Addendum: 2

Date: 08/21/2026

Project: Northwest Allen County Schools
Huntertown Elementary School Mechanical Upgrades

Comm #: 26842

E101

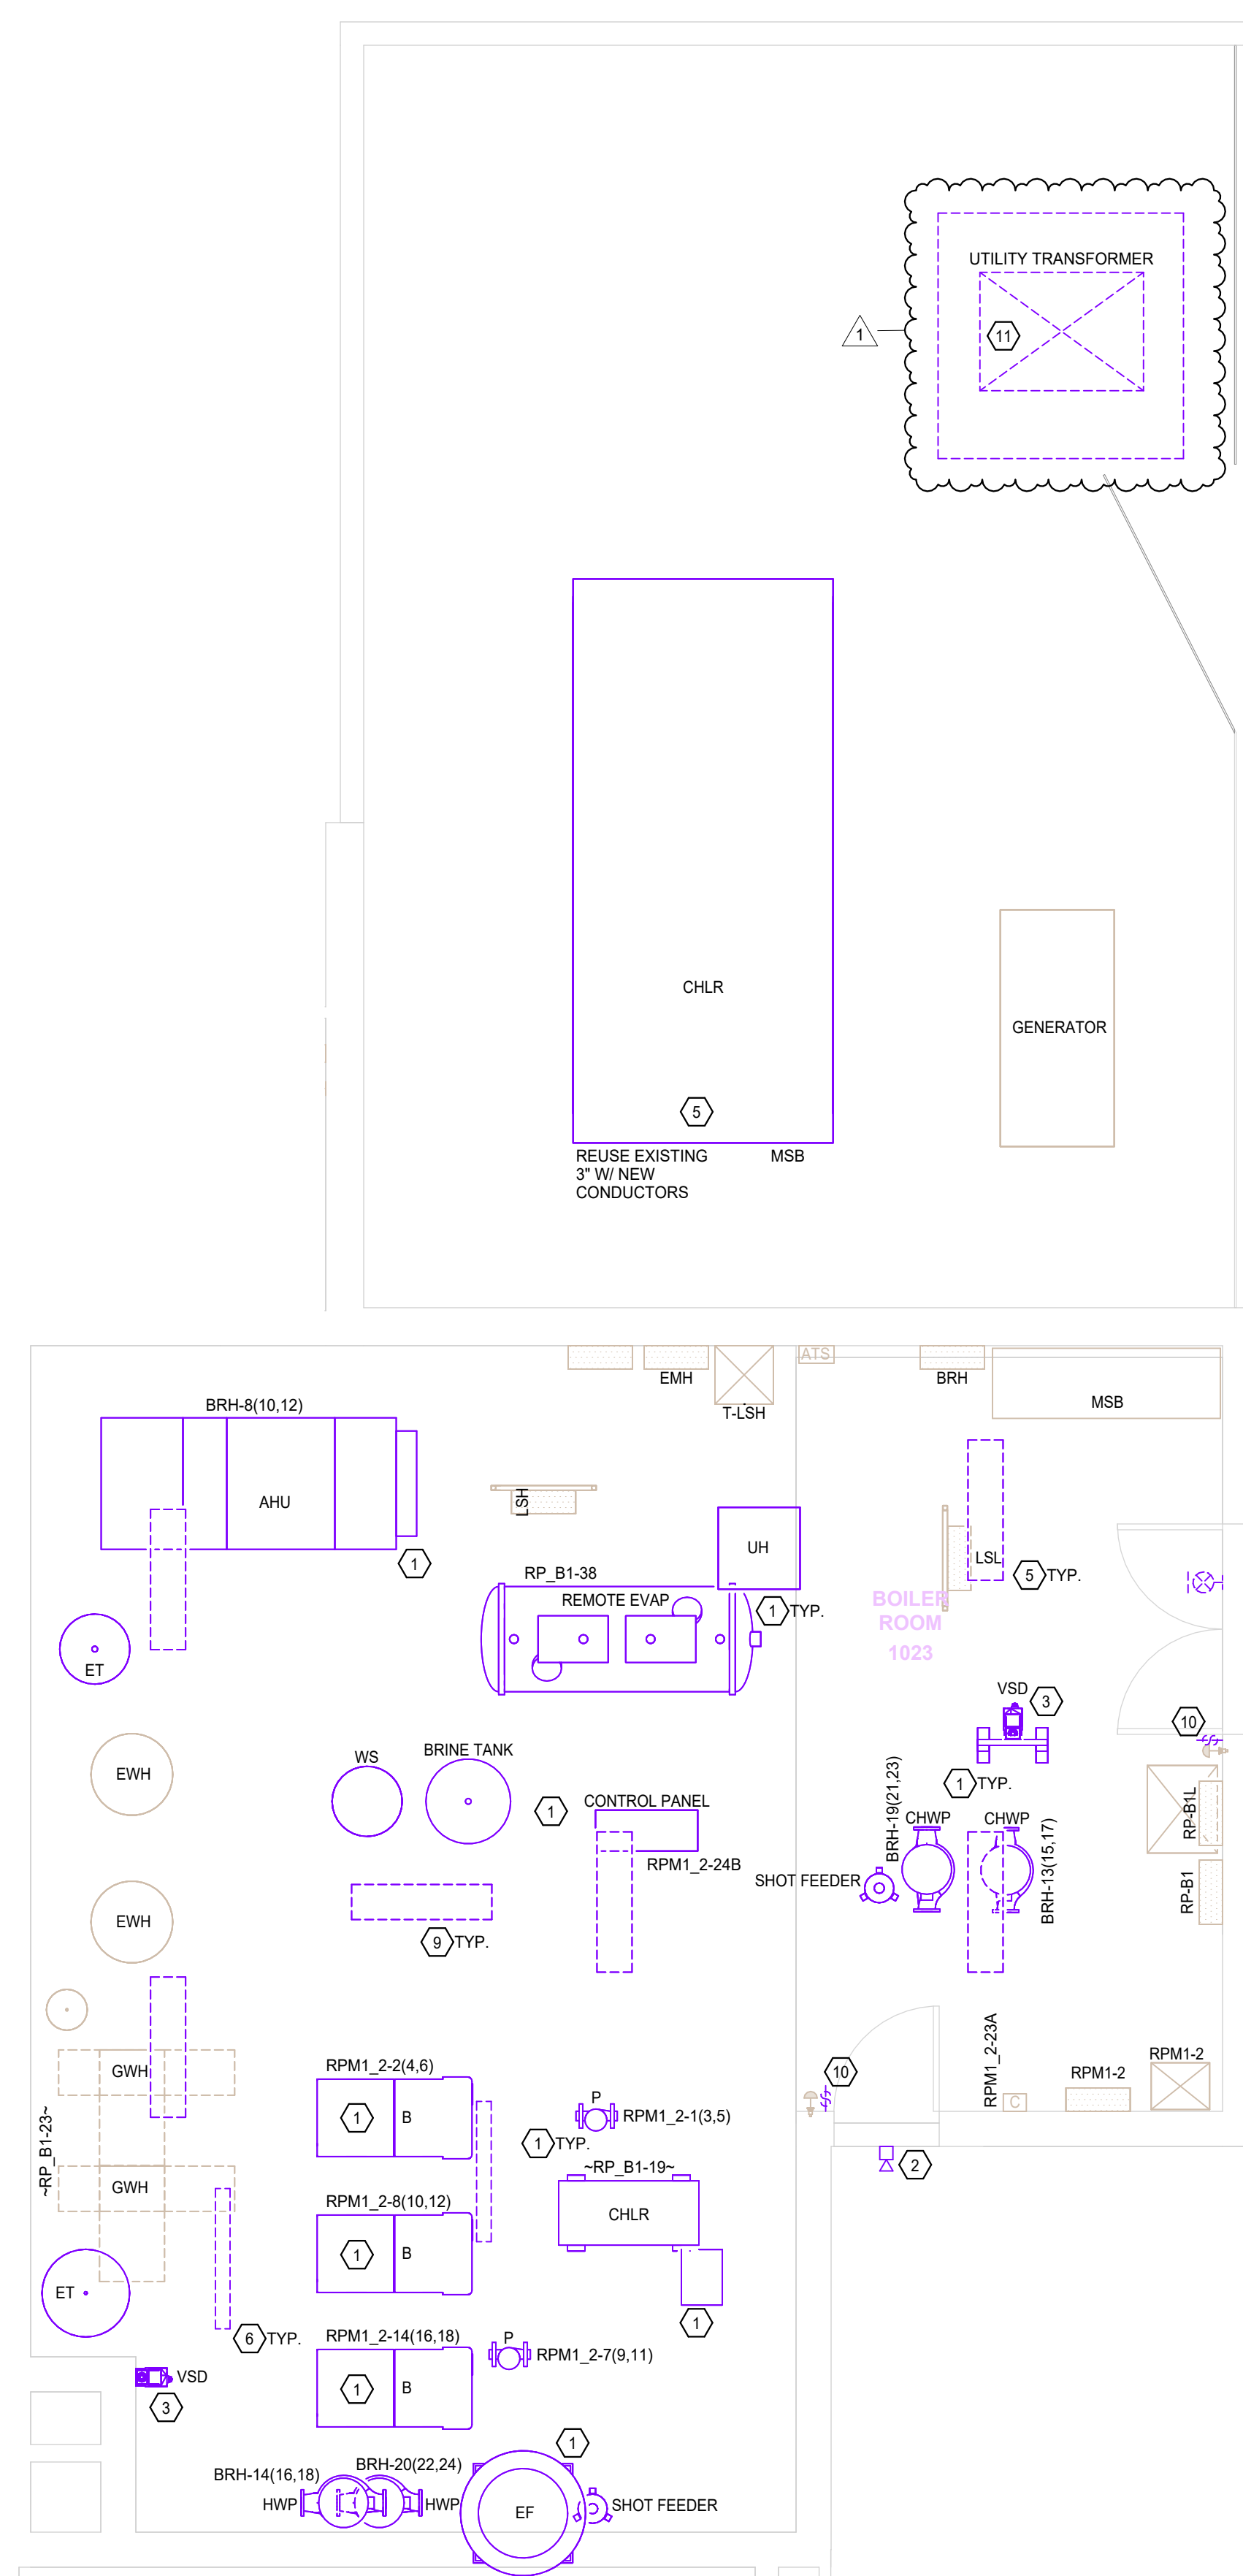
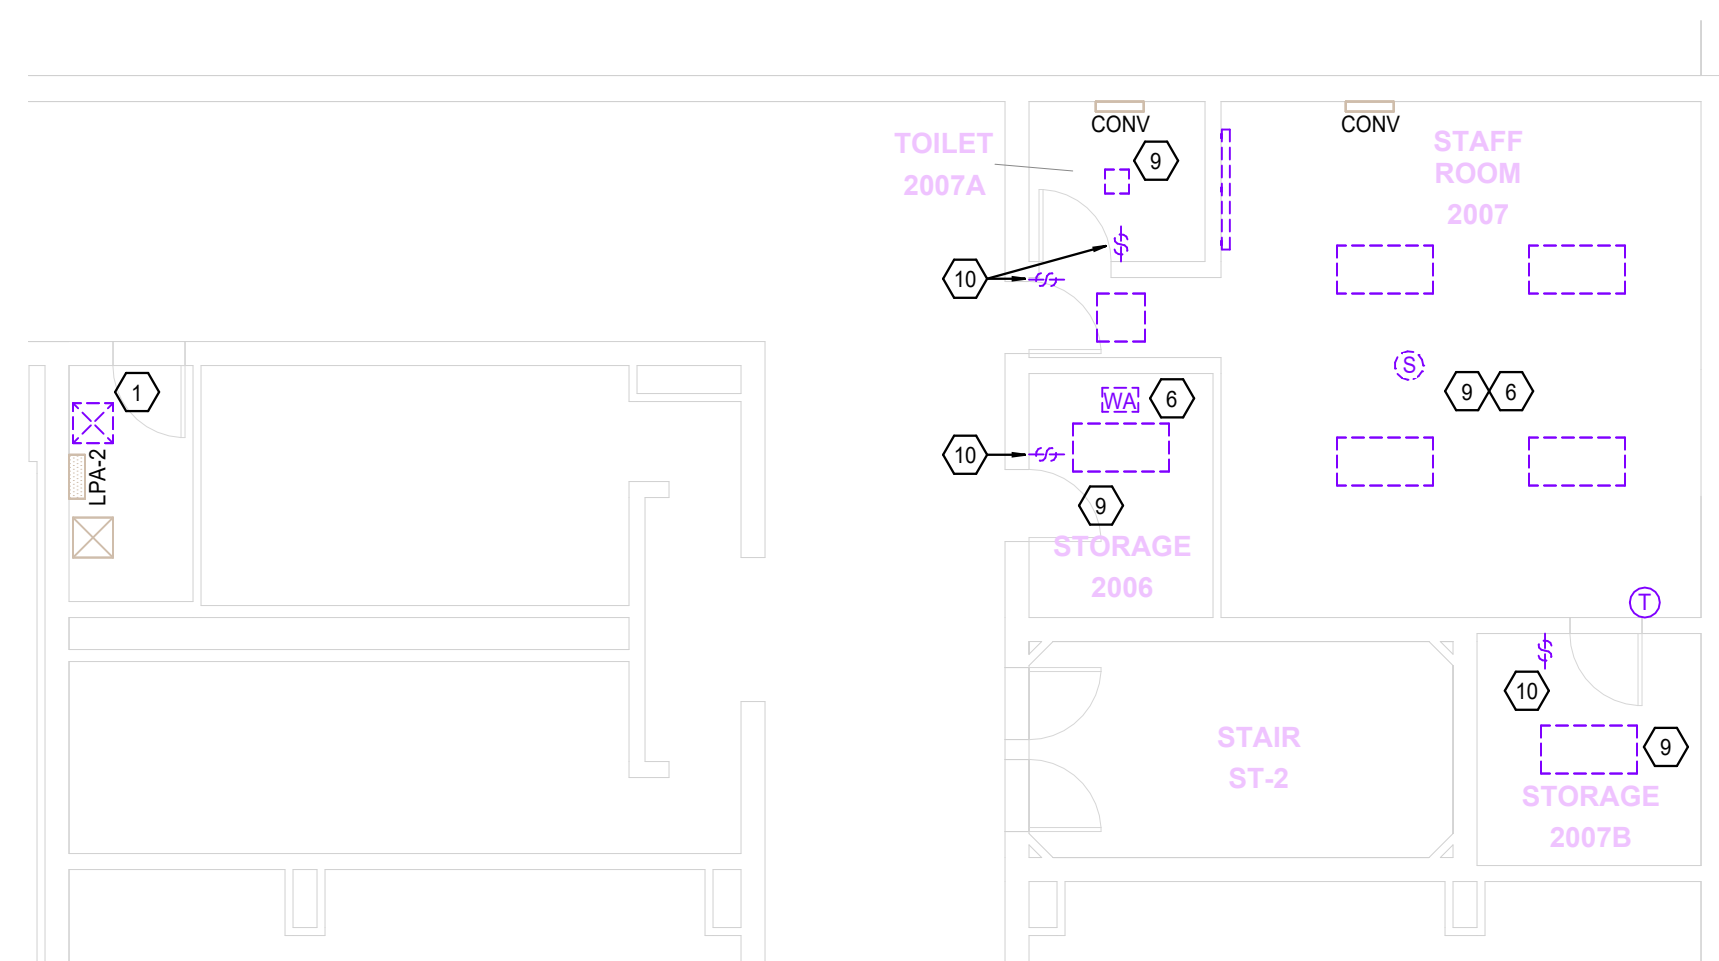
- A. Existing fire alarm control panel location shown. Existing Fire alarm control panel is Notifier NFW2-100.
